MONTGOMERY COUNTY HISTORIC PRESERVATION COMMISSION
STAFF REPORT

Address:	6 Primrose Street, Chevy Chase	Meeting Date:	12/15/2021
Resource:	Contributing Resource Chevy Chase Village Historic District	Report Date:	12/8/2021
Applicant:	Caitlin Steed David Easterday, Architect	Public Notice:	12/1/2021
Review:	Historic Area Work Permit	Tax Credit:	n/a
Case Number:	951380	Staff:	Dan Bruechert
Proposal:	Partial Demolition, Rear Addition, and Fenestration Alteration

PROPOSAL

Existing and Proposed
Left Side Elevations

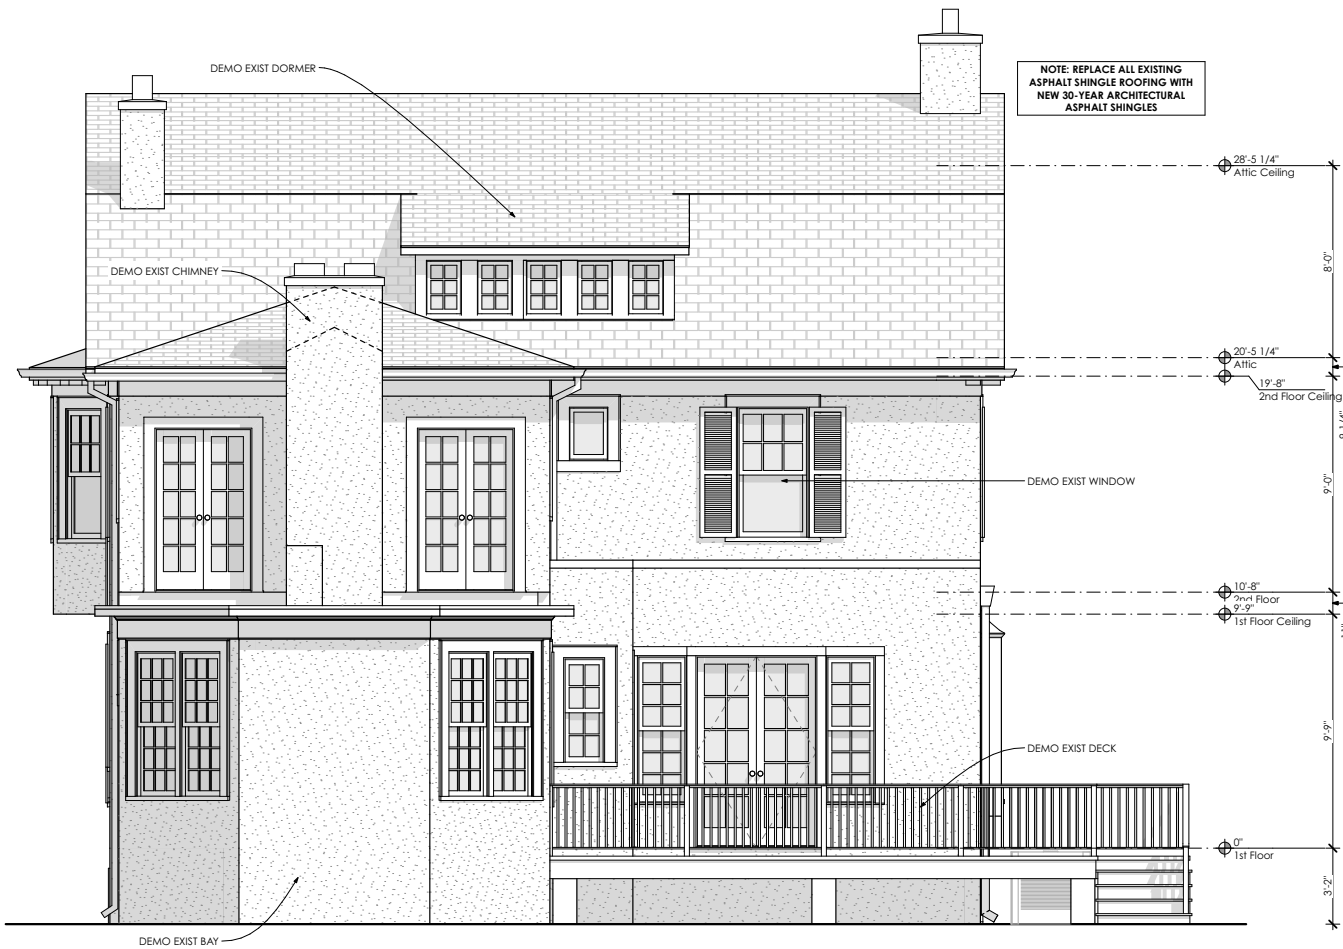
Third, the applicant proposes removing and replacing two attic windows on the left (east) elevation. The existing windows are six-over-six sash windows with shutters. The applicant proposes replacing these windows with two six-lite casement windows in the existing openings. One of the windows will satisfy egress requirements for a bedroom in the attic and the second window replacement will create a consistent appearance. Staff supports the window replacement under 24A-8(b)(4) and the *Design Guidelines*.

Finally, the applicant proposes replacing the large nine-over-nine window on the first floor of the left elevation. The application states that they will replace the existing window in-kind. However, the application does not provide sufficient documentation showing a need for the window replacement. Staff recommends the HPC include a condition to the approval of this HAWP that excludes replacing this window until sufficient documentation is provided to justify its removal and replacement. If the applicant can provide this additional information, Staff can verify that the replacement is in-kind and it will not require an amended HAWP.

1. Approval of this HAWP does not extend to replacing the nine-over-nine sash window on the left elevation. Detailed conditions and replacement specifications need to be submitted to Staff to verify that the window cannot be saved and that the replacement window matches the existing.

Existing and Proposed Right Side Elevations

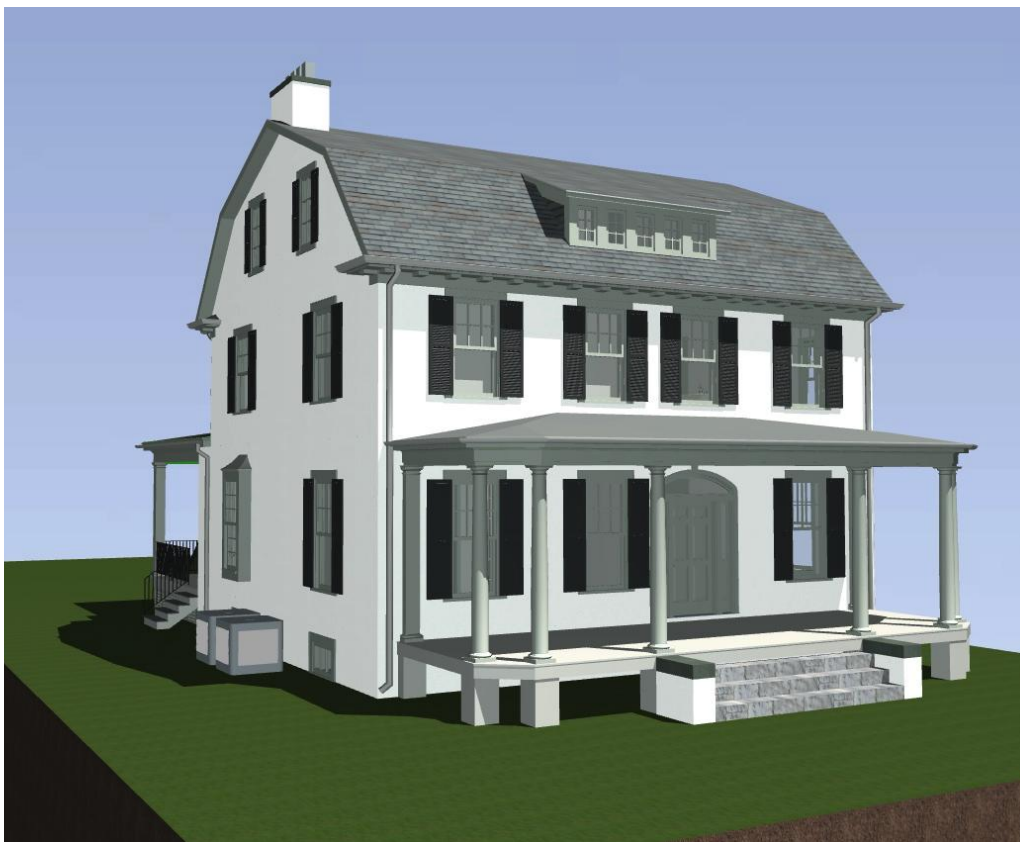
The second proposed change is the removal of an existing window on the second floor on the right (west) elevation and patching the window opening with stucco to match the existing wall. The window is a six-over-one sash window with shutters and appears to be historic. The window removal is proposed to

accommodate an interior reconfiguration. Staff finds the existing window is partially visible from the public right-of-way from a limited angle, but is located to the rear of the right elevation, so it contributes less to the historic character of the house. Staff finds that under a Moderate level of scrutiny, the house will continue to contribute to the character of the surrounding district and recommends the HPC approve the window removal.
